Project	IEEE 802.16 Broadband Wireless Access Working Group < http://ieee802.org/16 >	
Title	Comments on MS ranging and network entry in transparent and non-transparent mode	
Date Submitted	2007-09-17	
Source(s)	<p>Kanchei (Ken) Loa, Yi-Hsueh Tsai, Yung-Ting Lee, Hua-Chiang Yin, Shiann-Tsong Sheu, Youn-Tai Lee,</p> <p>Institute for Information Industry 8F, No. 218, Sec. 2, Dunhua S. Rd., Taipei City 106, Taiwan</p> <p>Kerstin Johnsson</p> <p>Intel Corporation 2111 NE 25th Ave Hillsboro, OR 97124</p> <p>[add other co-authors here]</p>	<p>Voice: +886-2-27399616 Fax: +886-2-23782328 loa@iii.org.tw</p>
Re:	IEEE 802.16j-07/043: "IEEE 802.16 Working Group Working Group Letter Ballot #28"	
Abstract	This contribution proposes to correct and merge the paragraphs in MS ranging and network entry in both transparent and non-transparent mode.	
Purpose	Text proposal for 802.16j Draft Document.	
Notice	<i>This document does not represent the agreed views of the IEEE 802.16 Working Group or any of its subgroups. It represents only the views of the participants listed in the "Source(s)" field above. It is offered as a basis for discussion. It is not binding on the contributor(s), who reserve(s) the

Figure 3 Response latency and T48 timer for using RNG-REQ message

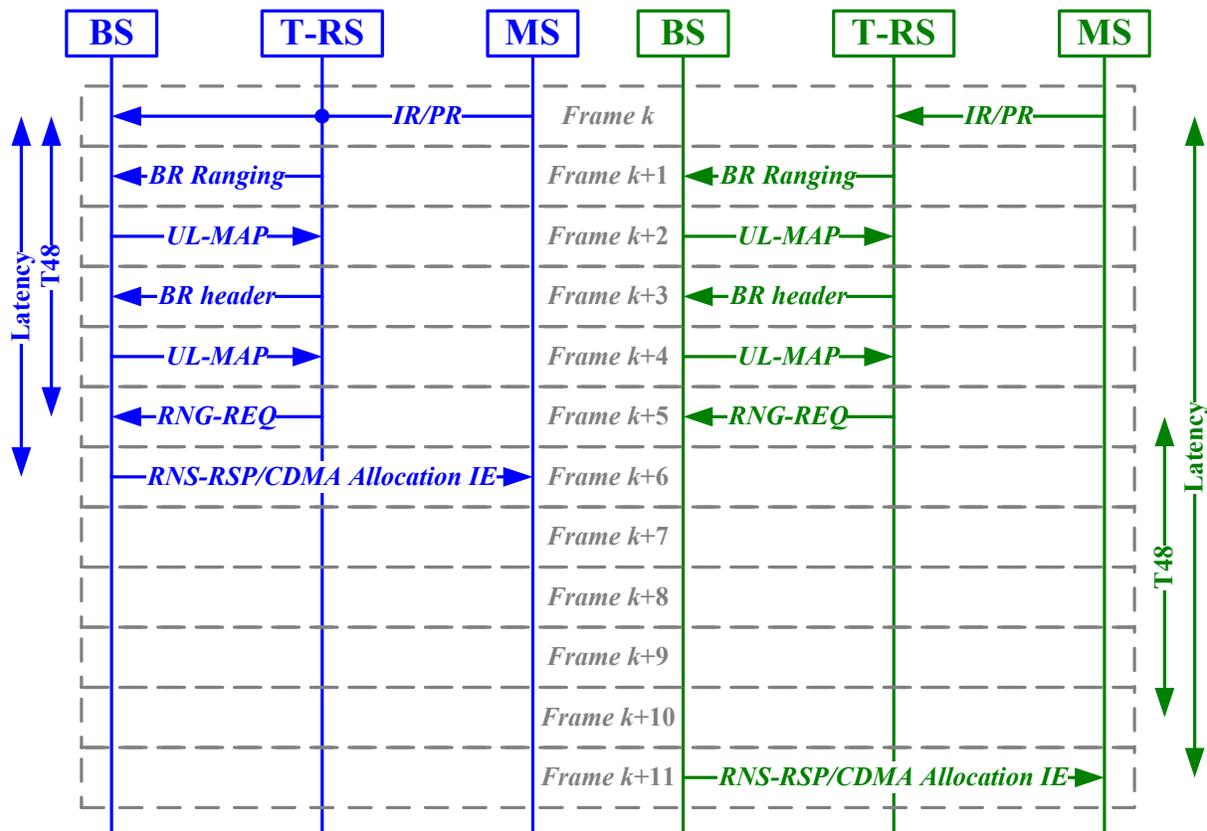
3. The MR-BS in the transparent mode may receive the MS ranging code directly or indirectly through the RS. If the MS ranging is received by the MR-BS and RS, the T48 timer is triggered immediately as soon as received by MR-BS. If the MS ranging could only be received by the RS, the T48 timer is triggered after MR-BS receiving the relaying message with the MS ranging code from the RS. Therefore, the actual waiting time for the MR-BS is the T48 plus the latency of relayed MS ranging code. In order to resolve this issue, the value of T48 timer under the indirect scenario, where only the RS receives the MS ranging code, must be adjusted by the latency of relaying MS ranging code, such that the actual waiting is equal to the value of T48 for the direct scenario, where the MR-BS receives the MS ranging code directly.

For example, in an indirect scenario described in the right one of figure 3 with T48 set to 5 frame (25 ms for 5-ms frame), MR-BS receives the relaying MS ranging code from RS at 5th frame after MS sends initial ranging code, and then sends RNG-RSP (or CDMA allocation IE) at 11th frame. Thus, the minimum latency of initial or periodic ranging is 55ms. If we consider the implementation safety margin, the value of T48 is at least 6 frames (30 ms). Thus, the latency will be at least 13 frames (65 ms), which is larger than the value of T3 timer (60 ms for initial or periodic ranging). Hence, the latency becomes unacceptable since the T3 timer at MS side has already been expired. Hence, the adjusted value of T48 for the indirect scenario should be 30 ms (original T48) minus 25 ms (latency of relaying MS ranging code).

Figure 115a—Handling CDMA ranging code at a transparent RS

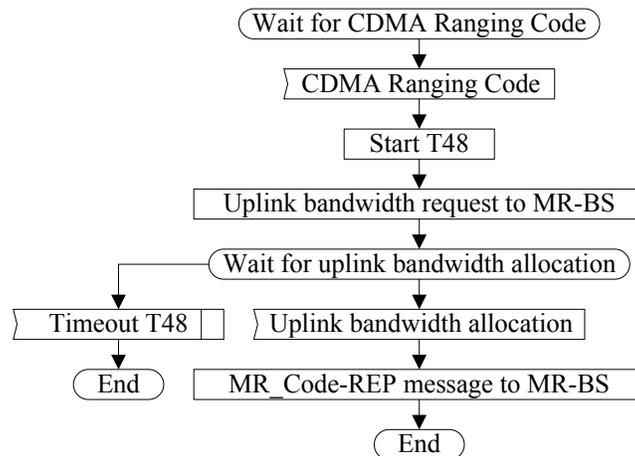
[Merge Figure 95 with, Figure 108a and Figure 108h; then move it to here as following indicated:]

Figure 115b—Handling RNG-REQ at a transparent RS

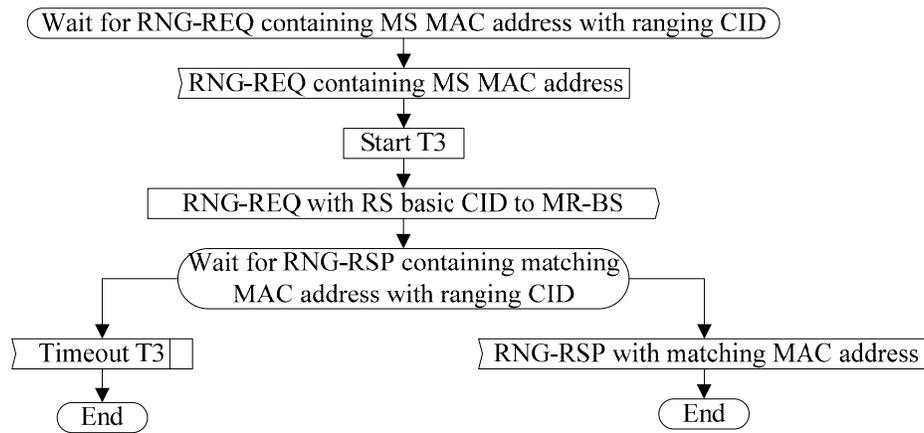
[Move Figure 95b to here and modified it as following indicated:]

Figure 115c—Handling RNG-REQ at a non-transparent RS

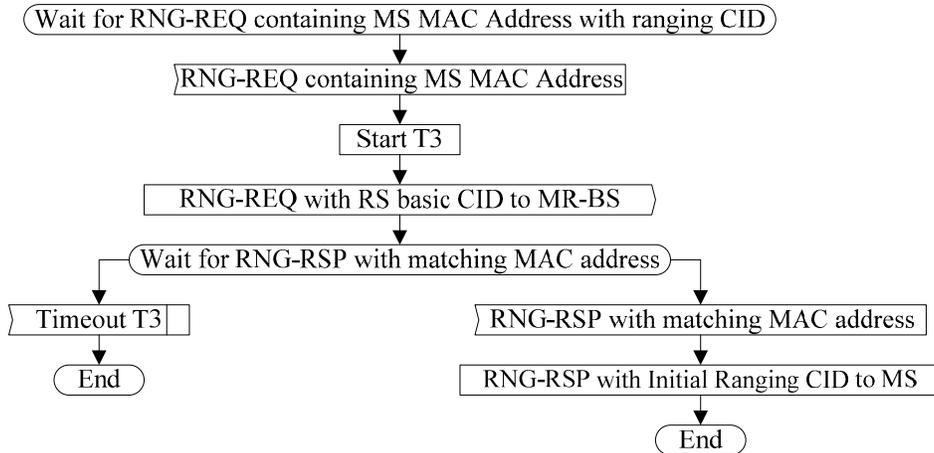
[Move Figure 95g to here, and modified it as following indicated:]

Figure 115d—Handling CDMA initial ranging code at a non-transparent RS with different preamble under centralized scheduling

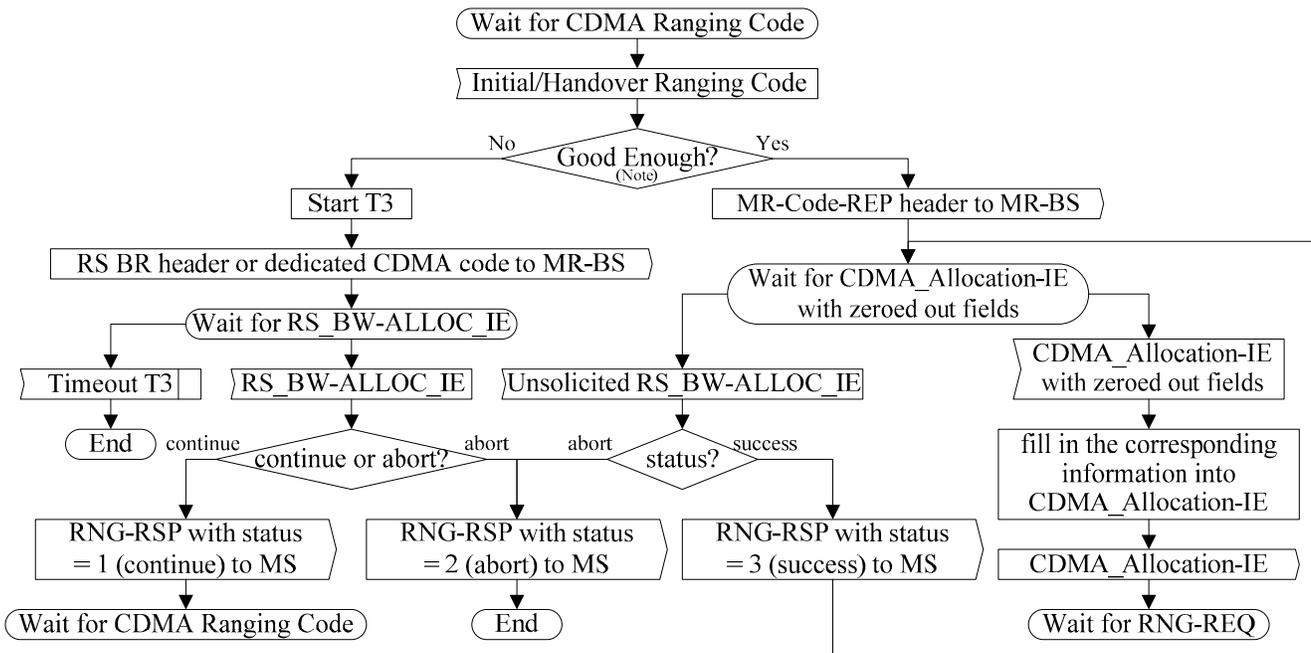
[Merge figure 95e with figure 95f, then move it to here, and modified as following indicated:]

Figure 115f—Handling CDMA ranging code or MR Code-REP message at an MR-BS

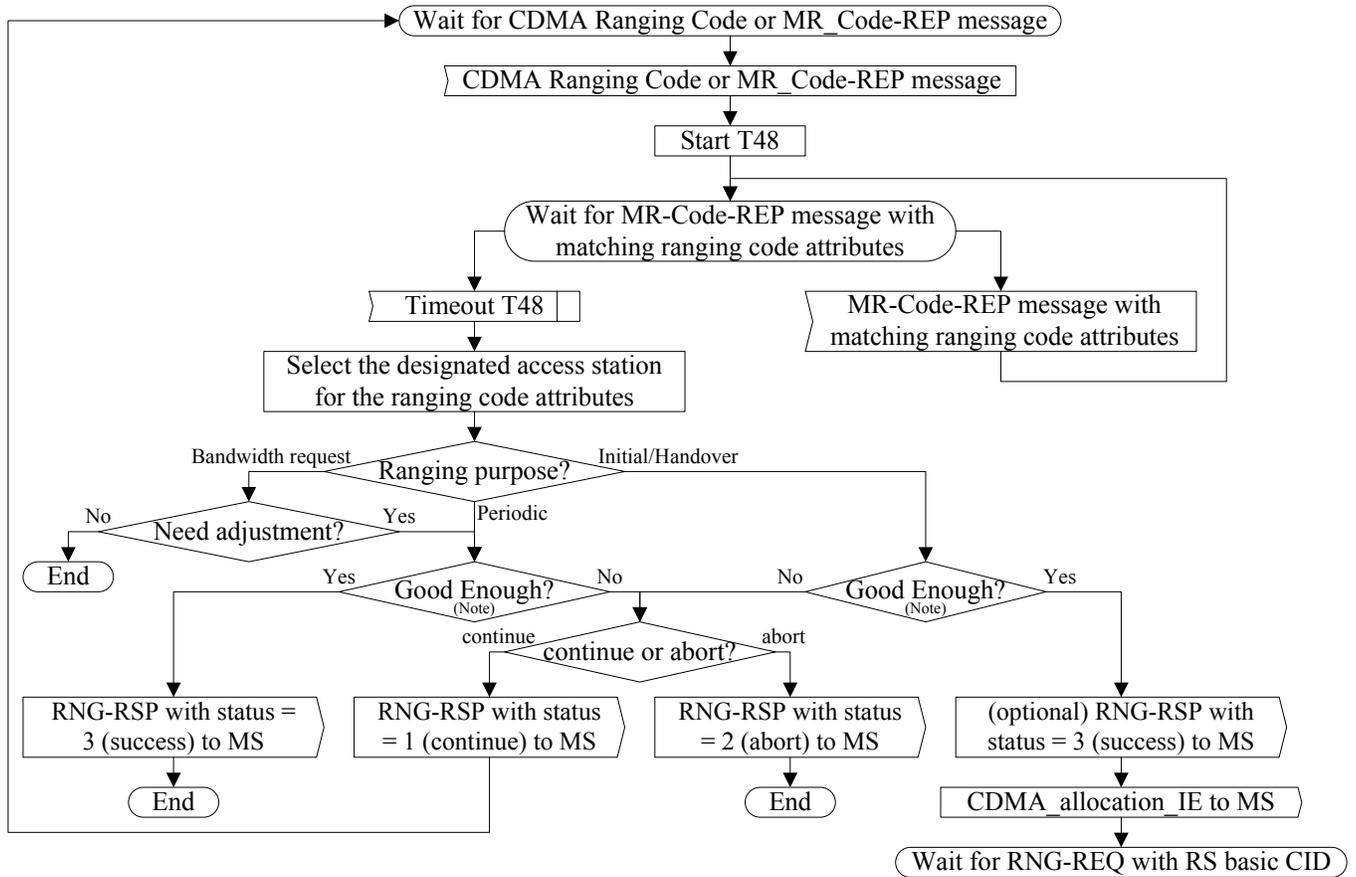
[Merge Figure 95c with Figure 108b and Figure 108i; then move it to here as following indicated:]

Figure 115g Handling MR Code-REP at MR-BS

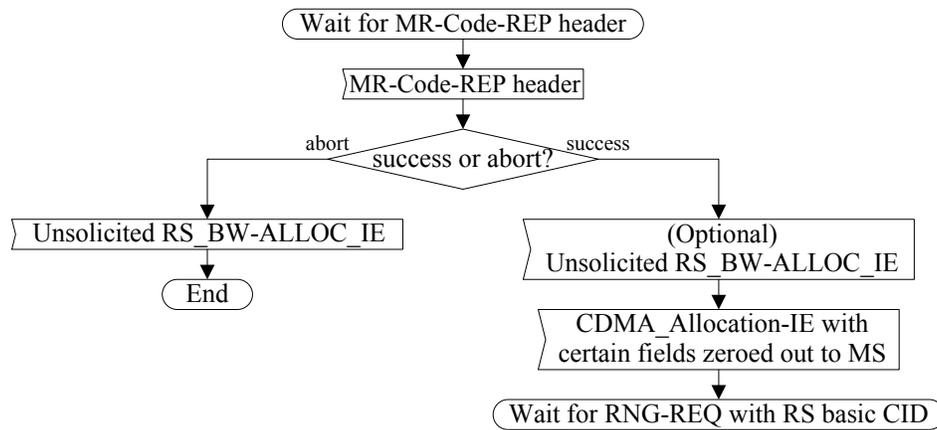
[Move Figure 95h to here, and modified it as following indicated:]

Figure 118a Handling CDMA ranging code at a non-transparent RS

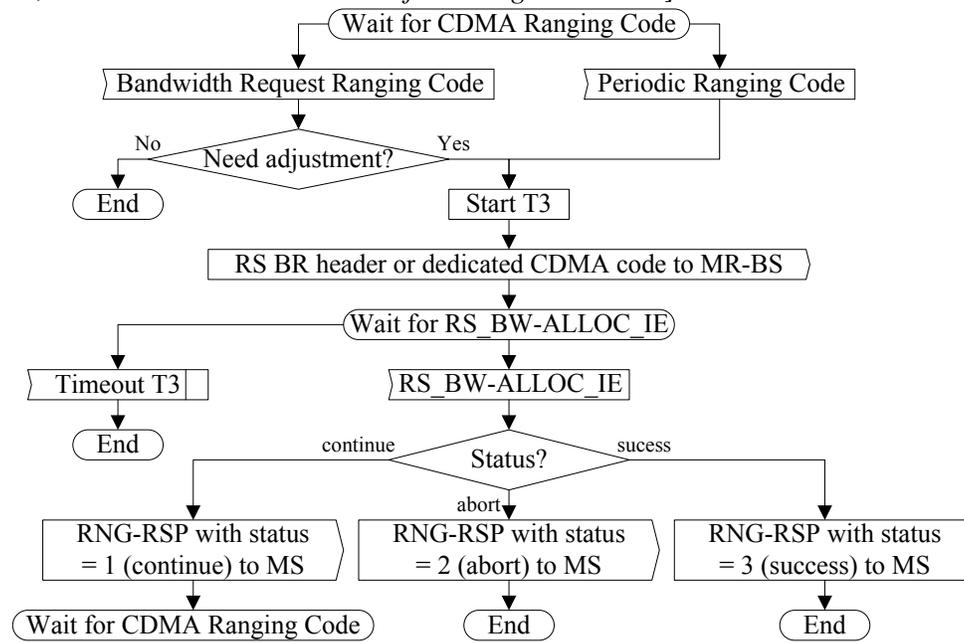
[Merge Figure 108c, and then move it to here as following indicated:]

Figure 118b—MS upstream transmission adjustment at an uplink-only transparent RS

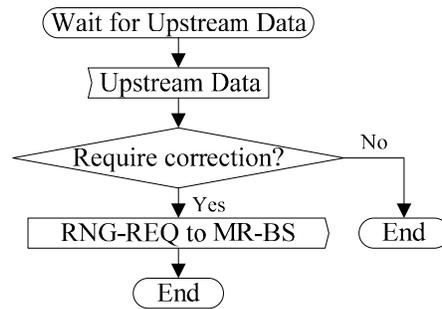
[Move Figure 108f to here, and modify it as following indicated]

Figure 118c—MS upstream transmission adjustment at a RS under centralized scheduling

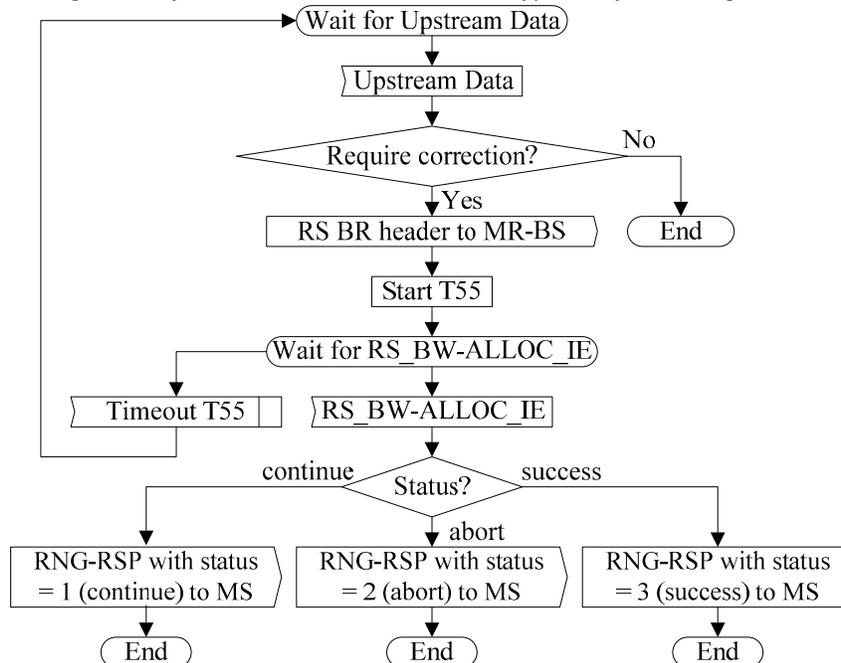
[Merge Figure 108f with Figure 108j, move it to here, and modify it as following indicated]

Figure 118d—Handle Handling RNG-REQ at an MR-BS

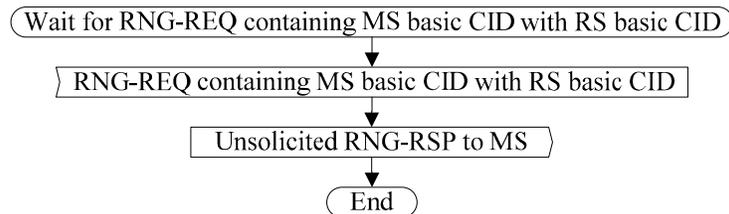
[Move Figure 108f and modify it as following indicated]
